RE: **Site Plan (Development and Design Review)
Crossroads Parkway Warehouse -21-07000018**

STAFF REPORT

**Subject: Development Review – Crossroads Parkway Warehouse
Technical Review Project # 21-07000008**

**RE : Crossroads Parkway Warehouse Site Plan – Crossroads Parkway
TRC No. 21-07000018**

Crossroads Parkway Warehouse Elevations

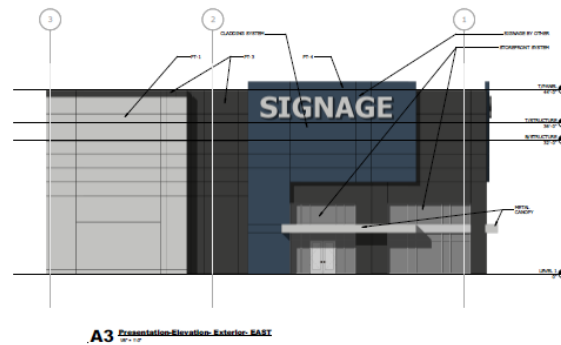
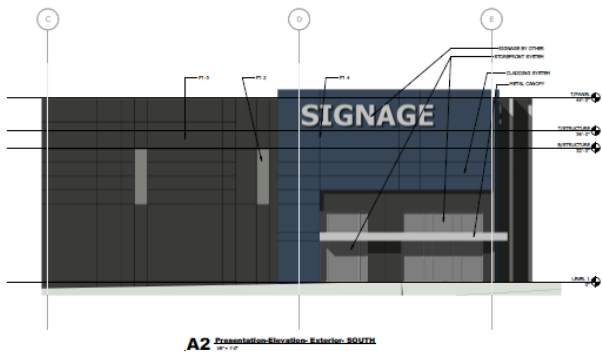
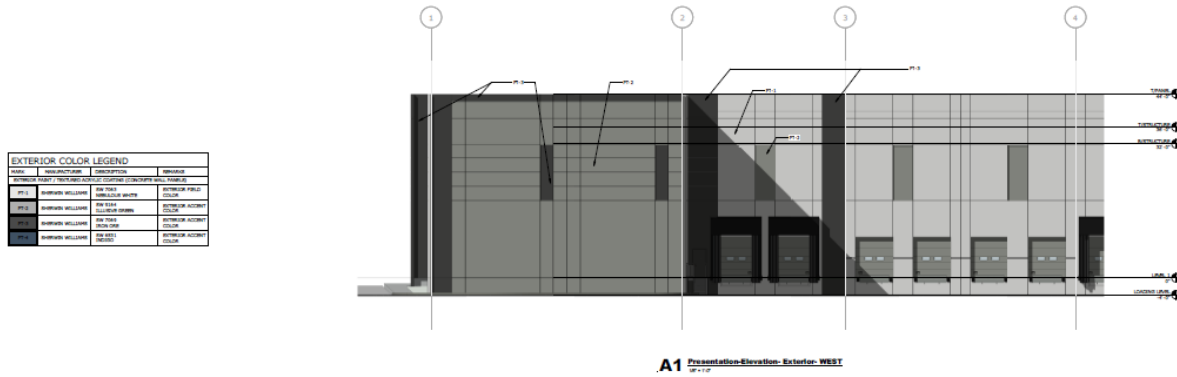
4. Sidewalks shall be provided along the Crossroads Parkway right-of-way pursuant to City Code 125-317.
5. It is requested that some color be added to the elevations and that the corners of the building be articulated in a way that provided varying roof height or designs. Please see provided examples after this letter that show how other projects have designed their corner endcap spaces.

6. Note that signs will be approved as part of the Building Permit process.
7. Provide up-lighting to the outside of the building to help with lighting at night and to enhance security and visibility.

**201811_Crossroad
Parkway Wa...**

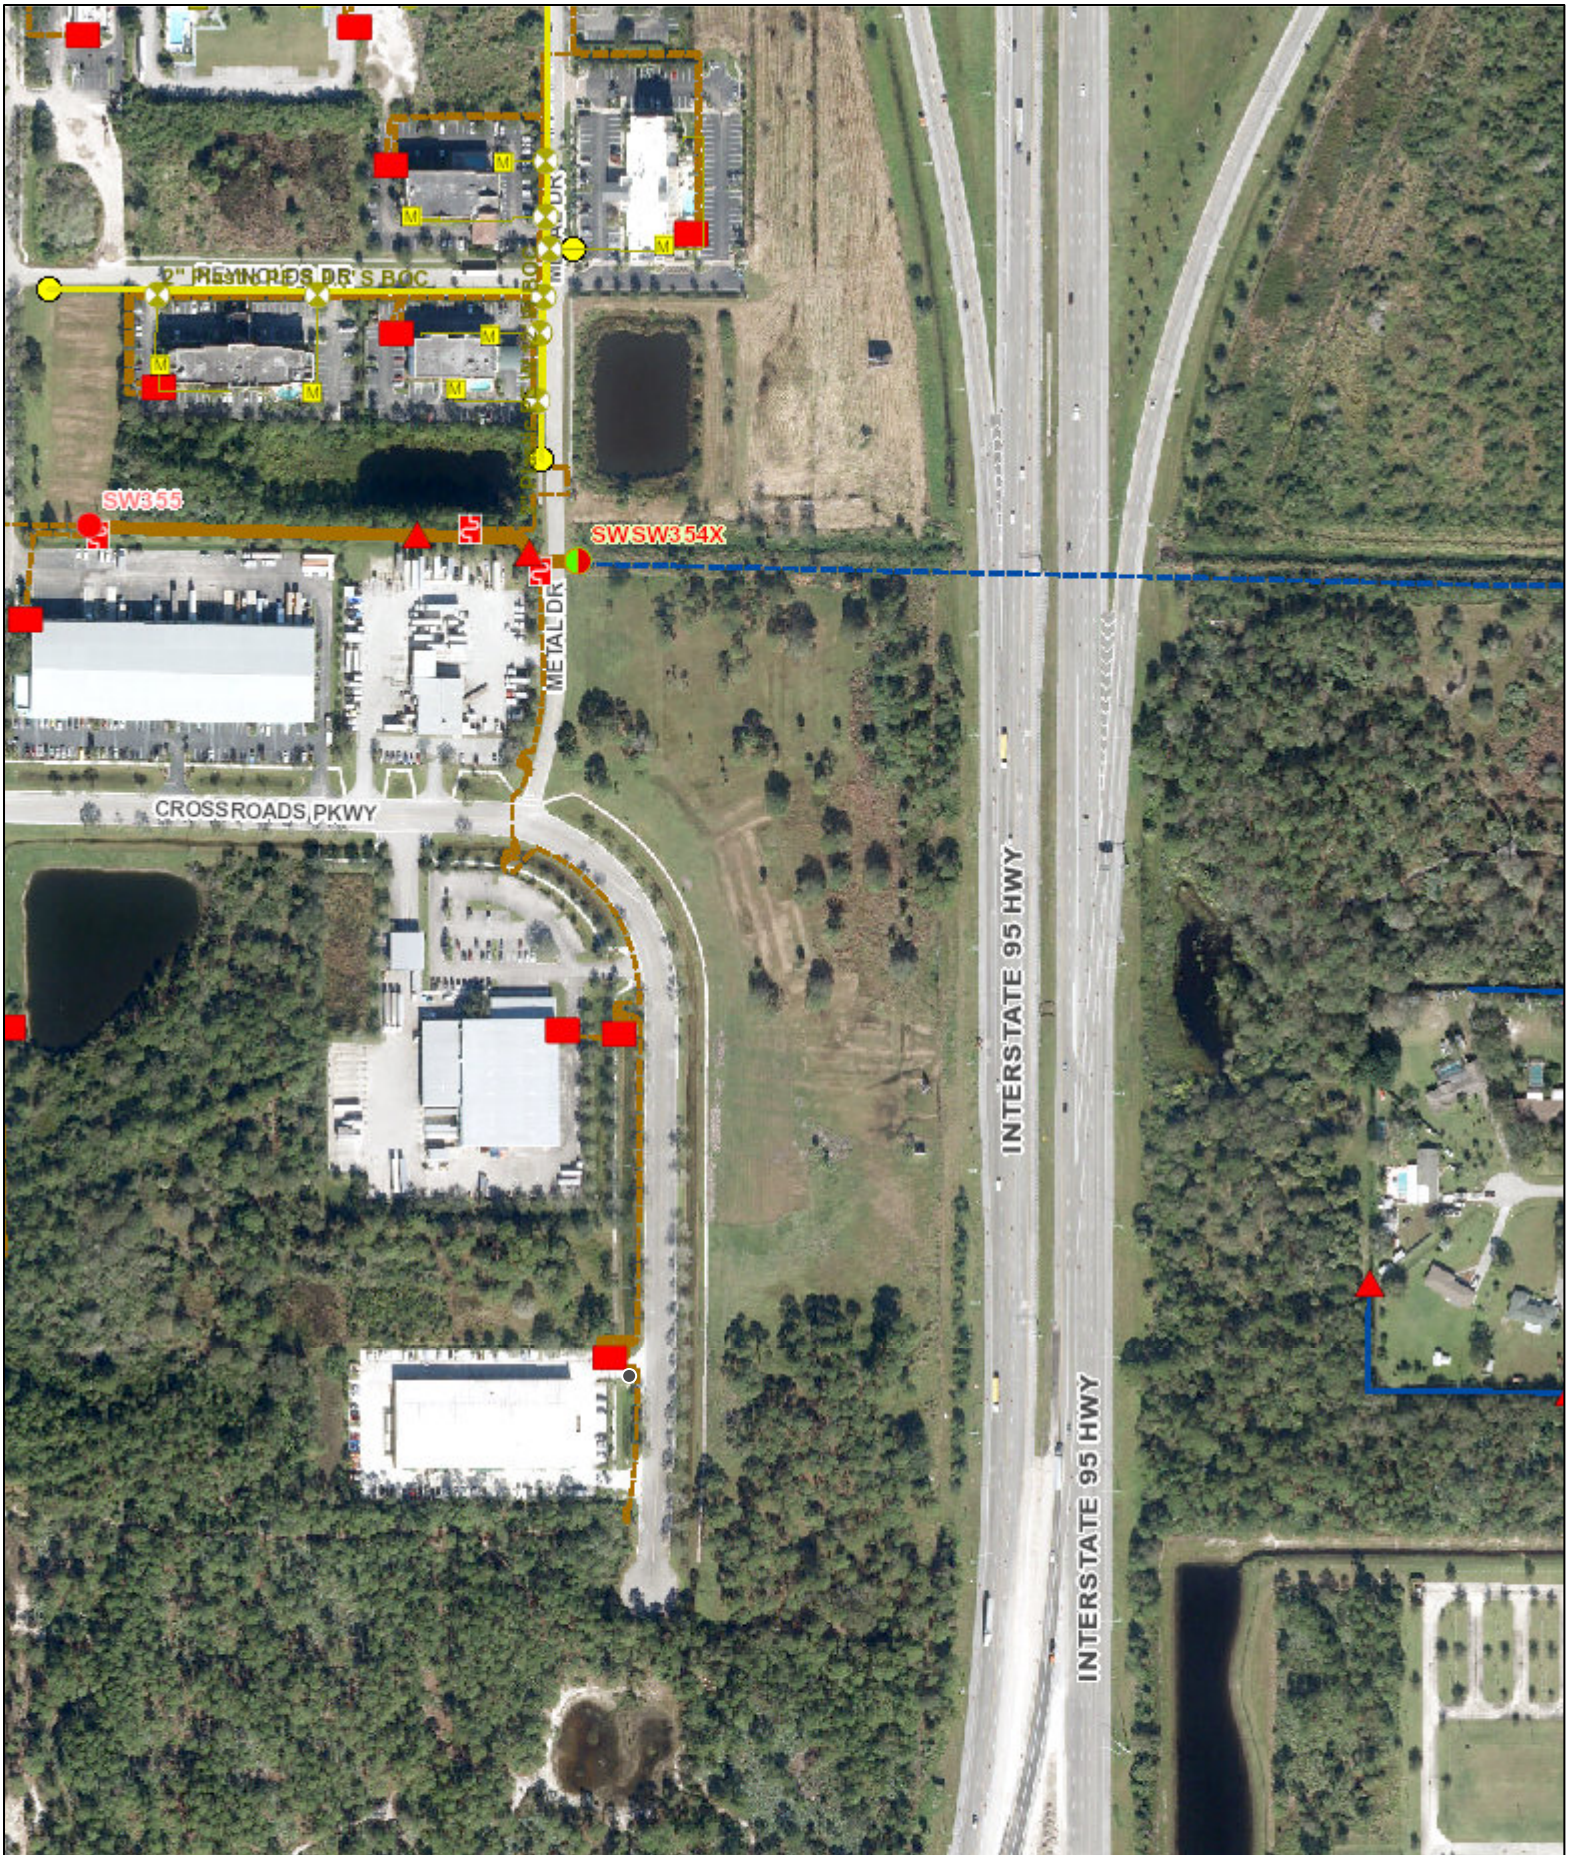
Gas: Service can be made available (via main extension from Metal Dr as shown in the attached GIS map). Please provide a copy of the gas riser diagrams with the anticipated load if the developer is

A utility easement will be required for all proposed FPUA facilities on the site.

The attached GIS map details the location of existing electric and gas facilities.
